Access Compliance Report

Public Rights-of-Way

Intersection ID: 10022037	Main Street: BRYANT_FARMS_RD	Cross Street: N/A	Location: SE
ADA ID: E0CA353F8DCE	Ramp Type: BlendTrans1	Initial Pass/Fail: Pass	Overall Compliance: No
Severity Score: 0			
Codes/Mitigation Info/Possible Solution		Field Measurements/Component Compliance

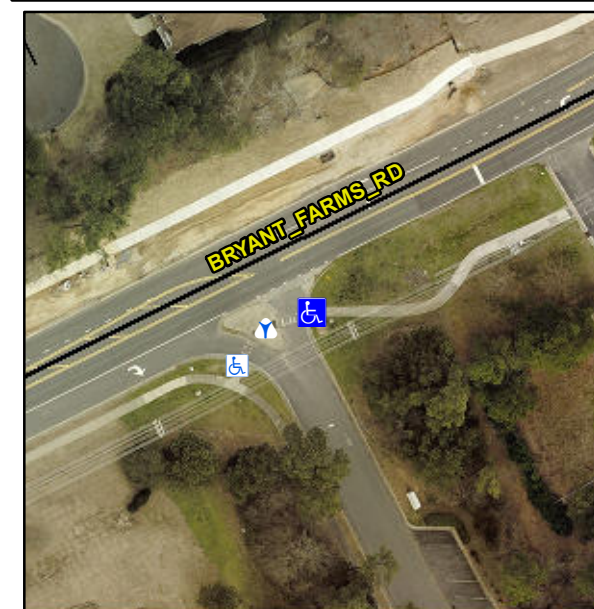
Not Found, R304.2.1, R305.2, R302.7

Yes	Ramp inside XWalk1?	Yes	N/A	Ramp inside XWalk2?	N/A
	Road Slope (%)	0.0		Clear Space?	Yes
	Road X Slope (%)	1.0	N/A	Clear Space to XWalk (in)	N/A
Yes	Any Obstructions?	No	Yes	Storm Grate/Utility Hazard?	No
	Obstruction Type			Storm Grate/Utility Type	
		N/A			N/A
			Yes	Surface Condition? (G/P)	Good
			No	Curb Slope (%)	7.2

Remove & Replace Curb Ramp With Two New Directional Ramps or Equivalent.
